Global Business Services

Marignane, 29/02/2016

This Letter is dedicated to the Ecureuil family (AS350/AS355/H125 and EC130/H130). It brings to your attention more information related to recent protective measures introduced by Emergency Alert Service Bulletins / Alert Service Bulletins, a status concerning some corrective solutions, some details about latest improvements carried out on the Product itself, and finally presents a synthesis of all actions carried out to reduce Costs of Operation and Maintenance for your fleet, even if some information were already provided in the previous Information Letter No. EC 014-2015 (February 2015) & No. EC015-2015 (July 2015), focused on H130 product.

Photo 1

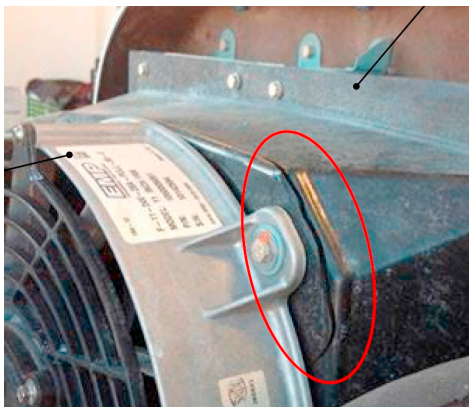
Several cracks were reported over the past months on the fan hopper mount (cf Photo 1).

In October 2014, the Emergency ALERT SERVICE BULLETIN No. EC130-05A020 Rev0 was released, requiring, as protective measure, a periodic visual check (during the P-inspection) of the hopper for crack detection at the attachments of the MGB oil fan to the hopper.

Photo 2

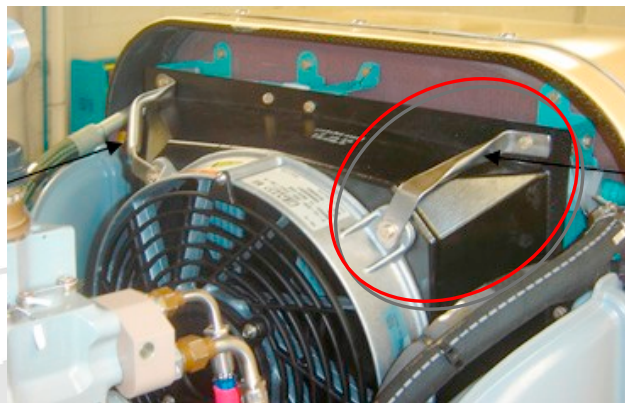
The Revision 1 of this EASB which was distributed in October 2015, provided a corrective solution to replace these checks: installation of 4 stainless steel rods to maintain the hopper mount. This corrective solution known as Mod 07-4547, is defined in Service Bulletin No. EC130-79-001 which has been released simultaneously (Photo 2).

Photo 3

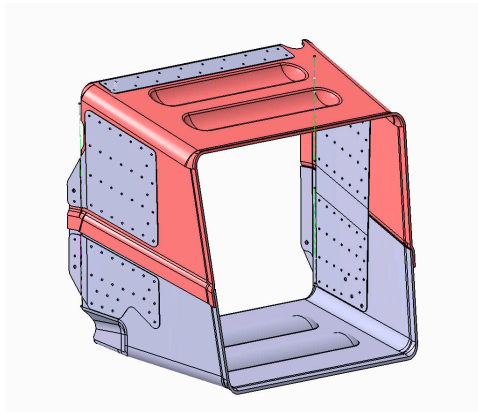
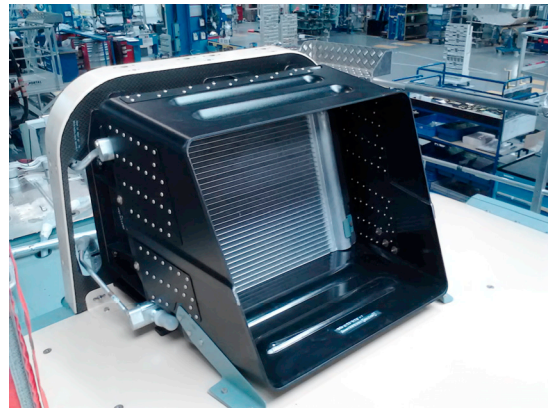
Several cases of cracks have been reported on the air intake on the H130 (this part is made of polycarbonate). The rupture of the part has not been classified as Unsafe. A first solution has been provided to give the possibility to reinforce the current parts (preventive and/or curative solution): this reinforcement consists in adding doublers made of aluminium material (cf Photos 3 & 4). It corresponds to Mod 07-4557, and the retrofit is proposed, Free Of Charge, under Service Bulletin No. EC130-21-013 (released on February 1st, 2016). An improved solution made of carbon material will be proposed before End 2016, on newly produced helicopters and in retrofit (on Customer request) .
